CALIFORNIA COASTAL COMMISSION

STAFF REPORT: REGULAR CALENDAR

Application No.: 9-23-0599

Project Description: Dredge approximately 70,000 cubic yards of sediment from the power plant intake cove, with transport and placement at an approved dredged material placement site approximately 2,000 ft. offshore of Morro Bay sandspit.

Figure 2. Approximate sizes and locations of eelgrass patches and beds (green highlights) in the DCPD Intake Cove. No eelgrass was found in the proposed dredge footprint (red polygon).

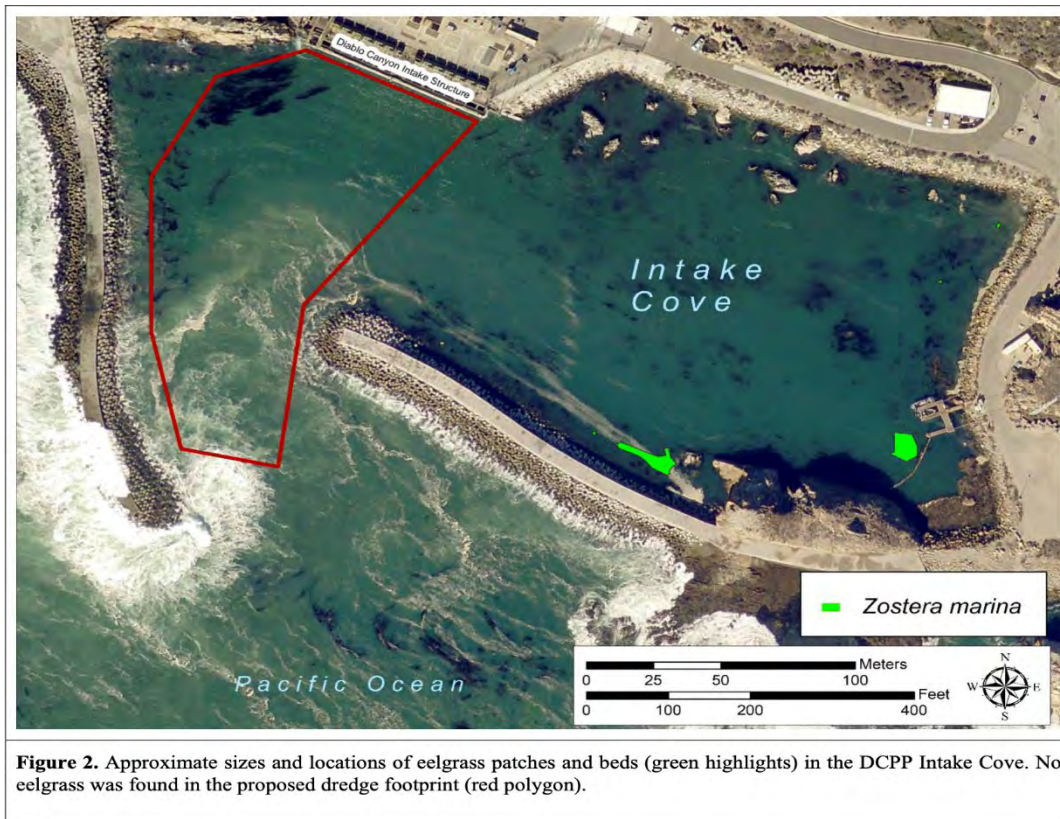
Based on the surveyed distribution of eelgrass within the intake cove in September 2023, the proposed dredging is likely to avoid direct impacts to eelgrass habitat. [Special Condition 1](#), which authorizes dredging only within the dredge footprint as shown on [Exhibit 2 – Project Site Plans](#), would ensure that areas of known eelgrass coverage are avoided. **Special Condition 3** requires submission of an Anchoring and Pipeline Placement Plan with designated anchoring locations that are not within areas of rocky reef or submerged aquatic vegetation.

Because the September 7, 2023 surveys did not provide 100% coverage of the area and the project's commencement date is not currently scheduled, [Special Condition 5a](#) requires a pre-dredge eelgrass survey prior to permit issuance and within 60 days of the start of dredging. That survey must specify eelgrass areal extent, bottom coverage, and shoot density and report the survey coverage, date of survey, and any interpolation methods used in the mapping. The pre-dredge eelgrass survey must be submitted to the Executive Director for review and written approval within 30 calendar days of survey completion, to confirm the amount and extent of eelgrass that could be affected by dredging. [Special Condition 5a](#) further requires an independent, third-party to perform post-dredge monitoring if any eelgrass is found within 150 feet of the proposed dredge footprint, the distance that was identified by Commission staff following coordination with NMFS staff, as most likely to be affected by dredging operations. If the Executive Director determines, based on a review of post-dredge monitoring results, that adverse impacts to eelgrass occurred, [Special Condition 5a](#) would require PG&E to mitigate for such impacts at a ratio of 1.2:1 (mitigation area: impact area) on-site, in full accordance with the CEMP guidance for the Central Coast region. The mitigation plan, including the location of and authorization to use the mitigation site, must be submitted to the Executive Director for review and approval.
